Proposed Residential Development

Portmarnock South Phase 1D

Stage 1 Road Safety Audit

Stage 1 Road Safety Audit – Feedback Form

Figure 2.5.1 Narrower footpath behind perpendicular parking spaces that might be blocked by overhanging vehicles

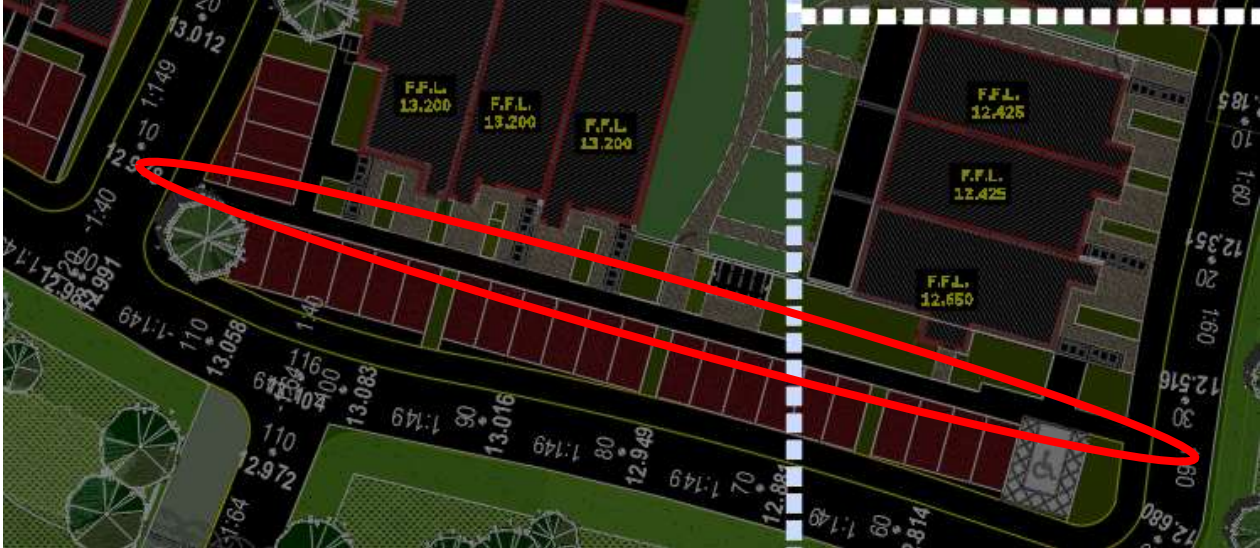
In one location on the scheme (see Figure 2.5.1) footpath is proposed both in front of and behind the perpendicular parking spaces. Vehicles parked in these spots might overhang the footpath. This could partially or fully block the footpath (narrower here than in other locations) and present an issue especially for more vulnerable road users, resulting in trips and falls.

Wheel-stops should be provided.

| 2.5 | Yes | Yes | Wheel-stops or hard verge will be used. | Yes |

Figure 2.7.1 Examples of pedestrian footway links that could improve pedestrian permeability of the estate

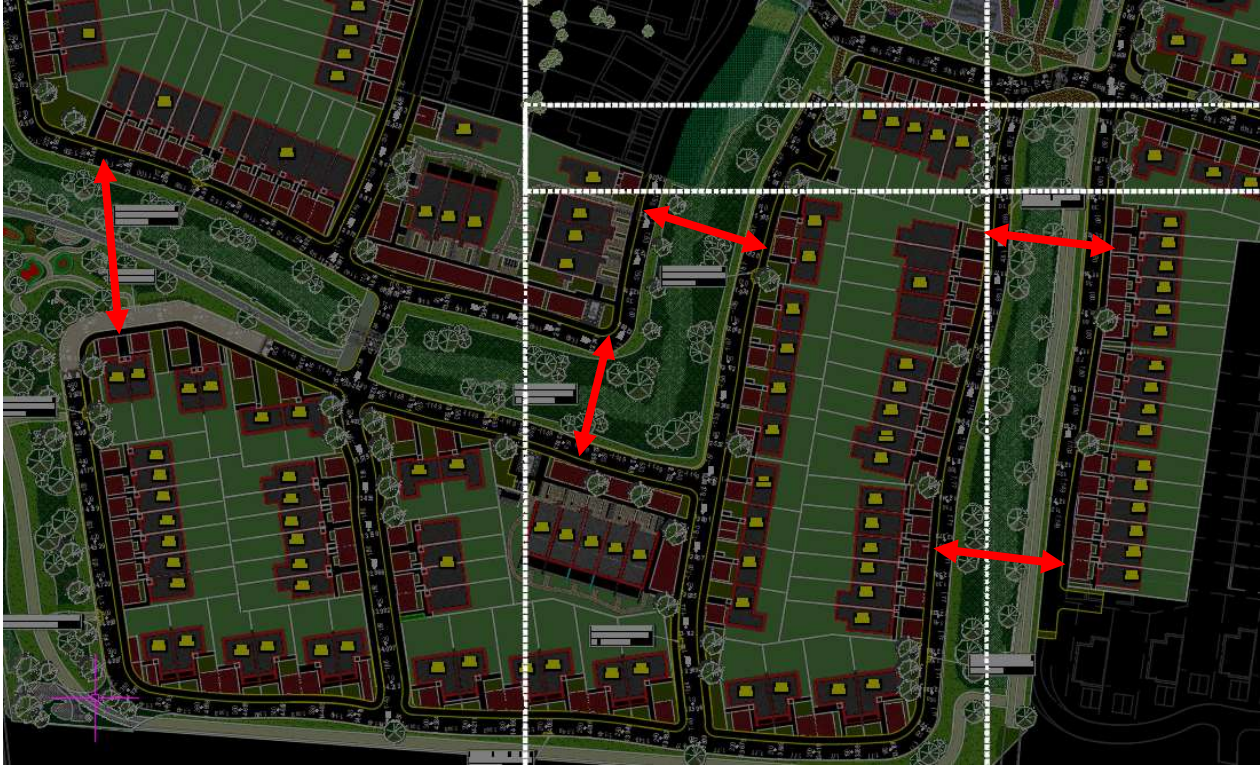
It seems that there are not enough pedestrian footway links interconnecting parts of the estate. Failure to provide good pedestrian permeability, by including pedestrian links where possible to shorten walking distances, could lead to pedestrians having to cross more roads and/or walk along carriageways, which increases their exposure to vehicular traffic and therefore could lead to pedestrian/vehicle collisions..

Likely pedestrian movements and desire lines should be analysed, and more permeability footway links provided along the likely vulnerable road users desire lines as, much as possible..

| 2.7 | Partially | No | One of the Objectives (GI 9) of the Local Area Plan for these lands was to minimise disruption to the historic townland boundaries. This constrains the amount of permeability links that can be provided. We are of the opinion that the links provided match the most relevant pedestrian desire lines. | Yes |

Figure 2.8.2 Likely path taken by south-western quadrant residents wishing to cycle north

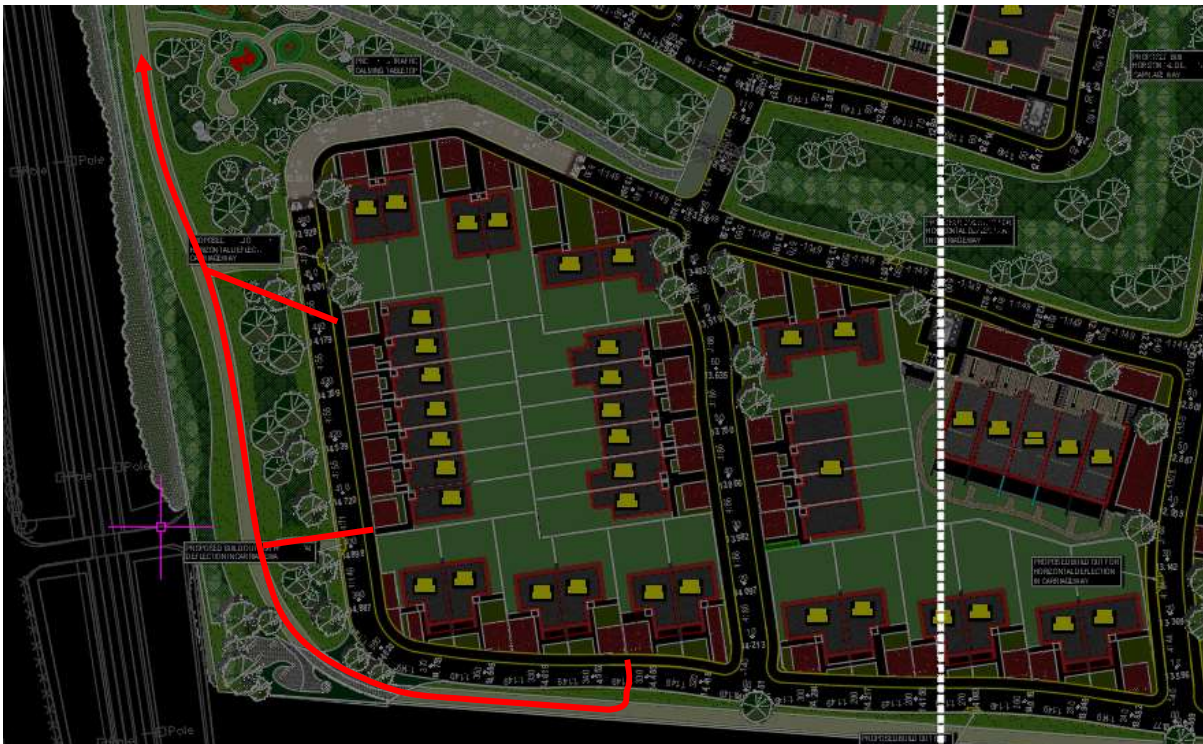
The walkway around the southern and western perimeter of the estate appears to be for pedestrian use only. It is considered quite likely that residents of the south-western quadrant of the estate wishing to cycle north will use this walkway rather than the estate roads. Lack of clarity with regards its function may confuse the users and lead to cyclist/pedestrian conflicts as pedestrians may not be expecting cyclists on the walkway.

Furthermore, cyclists wishing to join the cycle/pedestrian facility at the eastern side of the estate have no convenient connection to it from the southern side of the estate.

The southern and western perimeter walkway should be designated a cycle/pedestrian facility, It should be of sufficient width and detail, with adequate signage, and with adequate and convenient connection points.

| 2.8 | Yes | Yes | Updated drawing 02005 showing proposed connections to this shared surface path, are included with this application. | Yes |

Figure 2.11.1 Examples of various footway surfaces used throughout the scheme

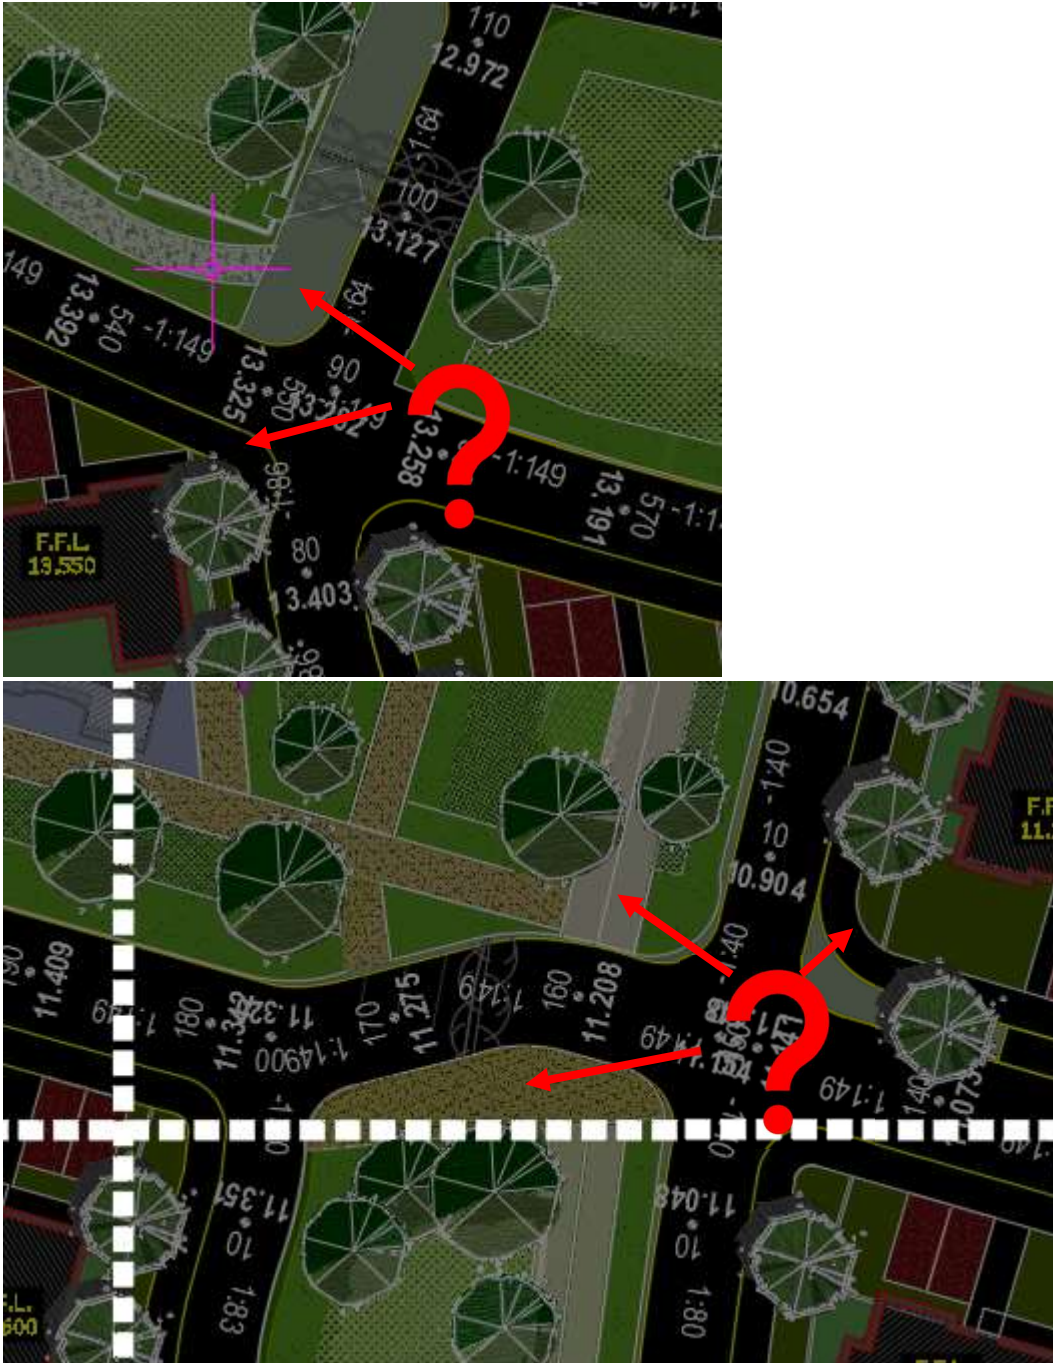
Details of paving surfaces have not been made available to the auditors, but it is understood from the drawing that several surface types are proposed for footways throughout the scheme. Whilst it is acknowledged that different surfaces may be used in recreational spaces like parks and playgrounds, the use of varying surfaces throughout the scheme without clear reasons for change could confuse visually impaired pedestrians, resulting in them coming into a conflict with vehicles. Consistency of design is one of the key features of a safe design for visually impaired pedestrians.

Footway surfaces should be consistent throughout the scheme as much as possible, and ideally matching those of adjacent phases of this development.

| 2.11 | Yes | Yes | Primarily three surface types proposed for 'paths' – Concrete for Footpaths, Asphalt for Shared Surface Paths and Gravel for Park Paths. | Yes |

Figure 2.14.1 Section of the access road where road environment seems unclear in character

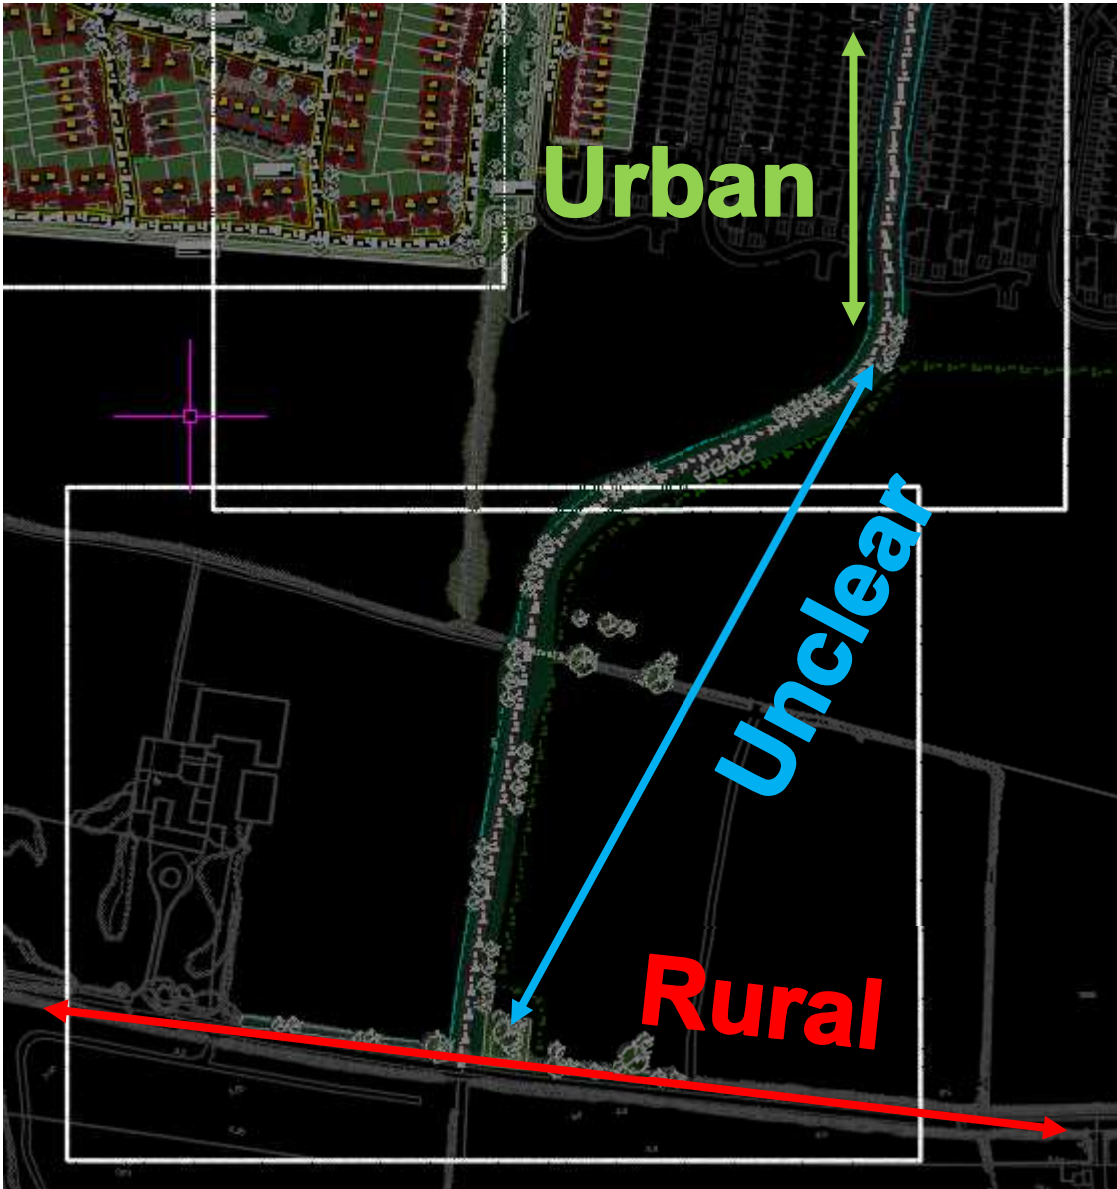
The details (like kerbs, road markings, public lighting) of the proposed access road connecting Moyne Road with the estate have not been made available to the auditors but it seems that the road environment over the southern section of this road is of unclear character. On the estate side it is urban with kerbs, footpaths, and artificial bends acting as traffic calming features, but on leaving the estate it suddenly becomes rather rural (no kerbs and footpaths, with vegetated verges), although with sharp curves. Drivers (especially going north from Moyne Road which is very rural in character despite the 60km/h speed limit) may misinterpret this road environment for a rural road, which could result in speeding, potentially leading to loss of control at sharp curves, and/or not slowing down enough on entering the estate, thus increasing the likelihood of conflicts with pedestrians. This could be exacerbated by darkness in the absence of public lighting.

Adequate signs and markings should be introduced for drivers entering and leaving the estate to make them aware of the changing road environment and the presence of sharp curves.

Public lighting should be installed along this stretch of road.

Suitable speed limit should be introduced.

| 2.14 | Yes | Yes | Lighting of this road is being provided. Updated drawing 02014 showing proposed entrance ramp and totem and speed (30kph) signage to raise drivers awareness they are entering an urban environment, are included with this application. | Yes |
